RISO Parts Change Information

Subject: Sheet; Suction Drive Shaft			Issue #: 081
New part#: 017-13283-009 New description: Sheet; Suction Drive Shaft Old part#: Old description:	Reason for Change ❑ Cost Effective ❑ Eliminate Claims ✓ Easier Operation ❑ Other	Manufacturing Cut-in Serial #: N/A	Applies to: All RA Models

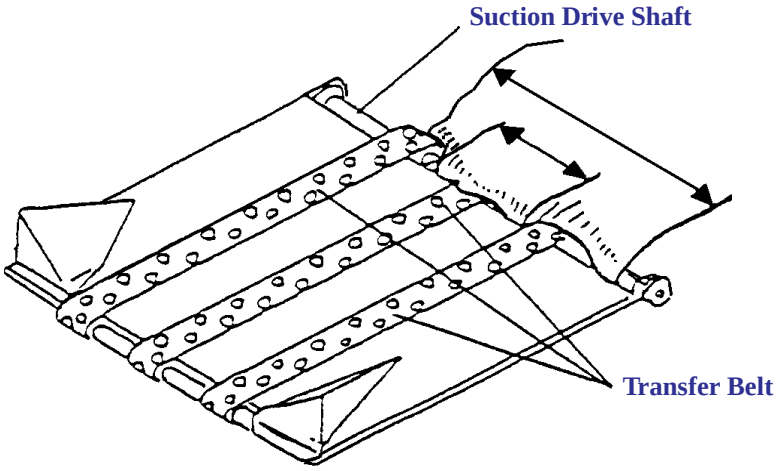
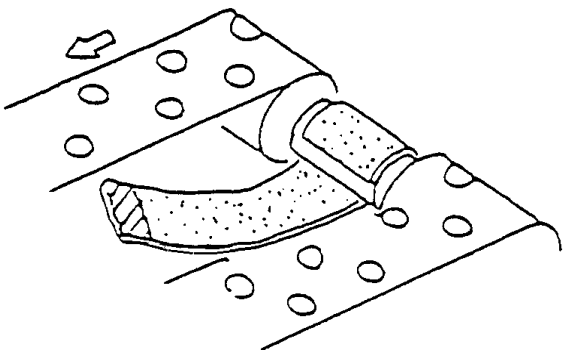
Certain paper sizes can wedge between the outside pulleys of the Transfer Belts. This is most likely to occur with light stocks, especially with a downward curl.

A Cushion Sheet has been developed to wrap around the Suction Drive Shaft and fill in the gaps between the Transfer Belt Pulleys. Wrap the Cushion Sheets around the Suction Drive Shaft as shown below.
